Solar Reflectance and Thermal Emittance for Residential and Nonresidential Roofs

CEC Workshop - July 13, 2006
W. Lee Shoemaker
Cool Metal Roofing Coalition

CODE CHANGE PROPOSAL

2008 Title 24 Building Energy Efficiency Standards Update

3-Year Aged Properties

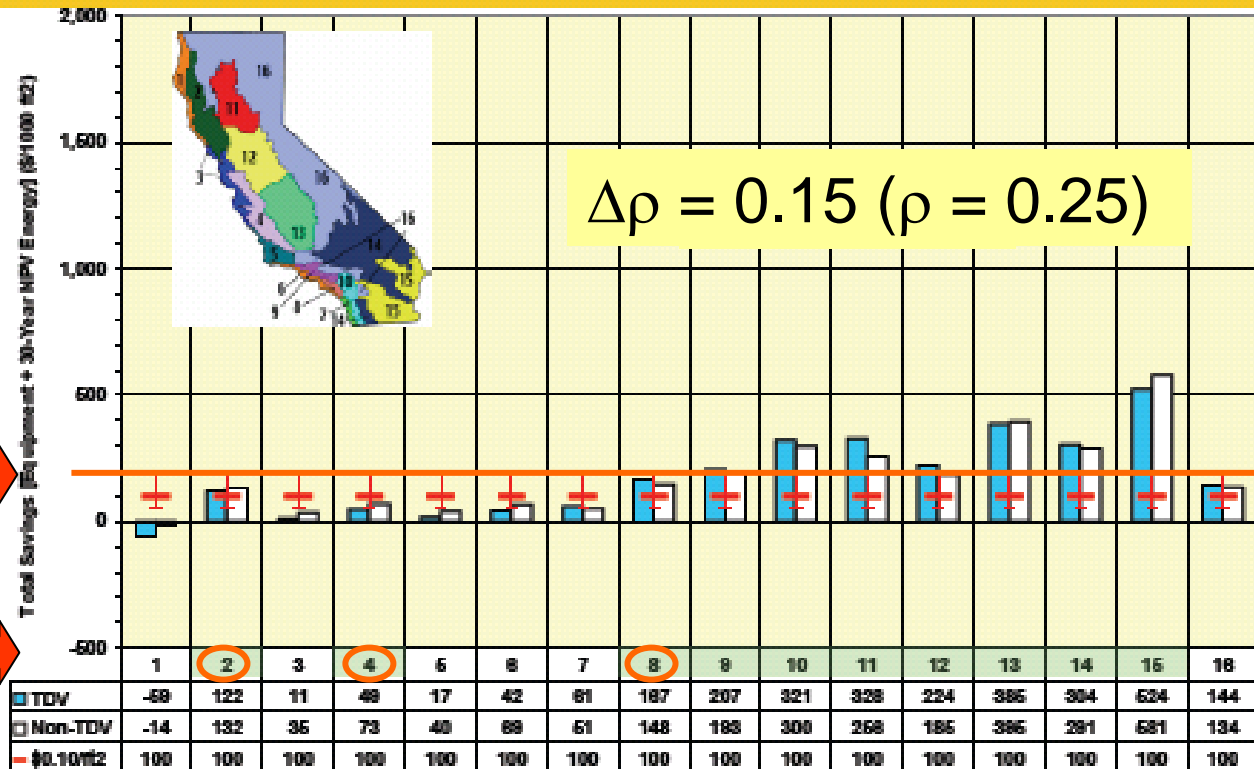
- $\rho_{\text{aged}} = 0.20 + 0.70 \times (\rho_{\text{initial}} - 0.20)$ **Too lenient?**

Steep-Slope Residential and Nonresidential

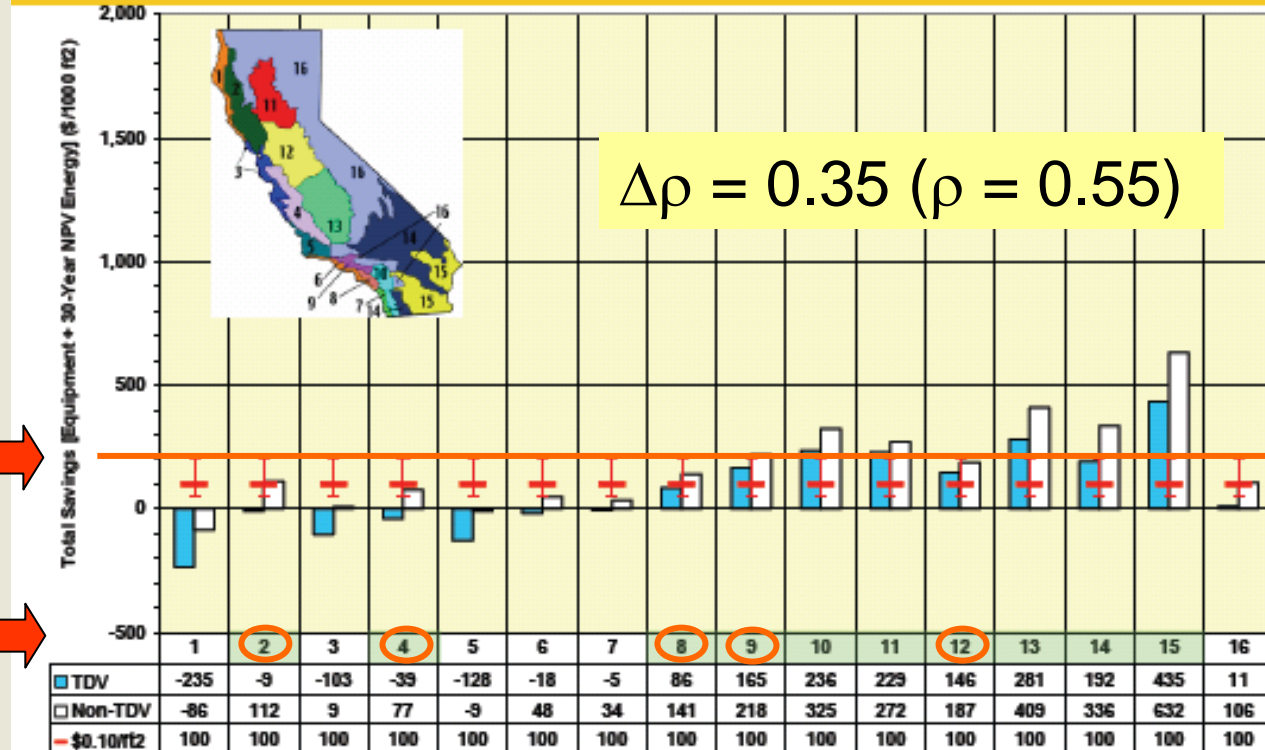
- 0.40 vs. 0.25
 - Color availability
 - 0.40 Eliminates 13 of 18 CRRC Color Families
